ENCLOSURE 03 / 99 DD+DIS 027.99E 1 Piece TMN6X MA 1 CM+9.5145.9110.0	Vacuum Hose of the Energy Chain

CM+9.5145.9110.0 Energy Chain Robot Carriage

Shortening of the Vacuum Hose of the Energy Chain concerning machines

Shortening of the vacuum hose by 230 mm.

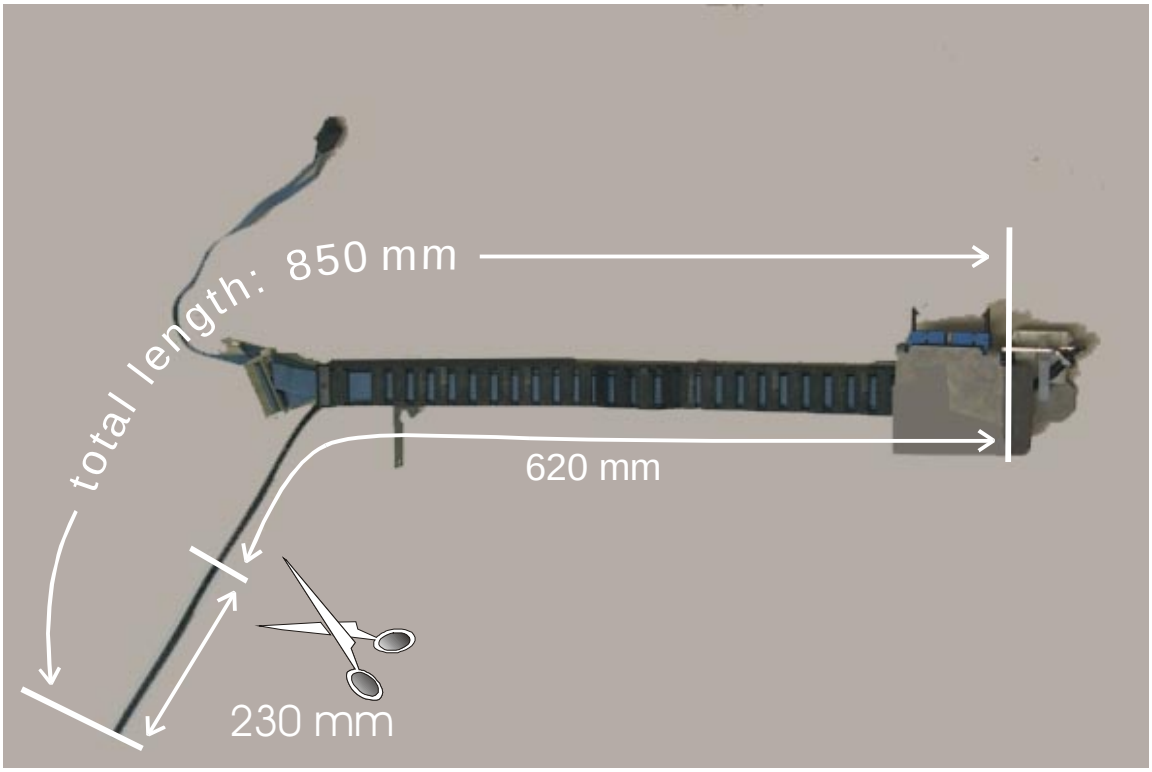
The length of the vacuum hose has been altered. Older machines up to SN 1212 / 5069 need the full length of 850 mm, machines from SN 1213 / 5070 on need a shorter vacuum hose with only 620 mm in length.

The length of the vacuum hose has to be shortened from 850 mm to 620 mm **(= 230 mm)** with machines

- as of SN **1213** (230 V * - version) or SN **5070** (208 V Δ - version) respectively.
- on which a modified IP- Transport is already installed (only when a new vacuum hose is needed)

Caution: Make sure that hoses which already have a length of 620 mm are **not** shortened a second time.
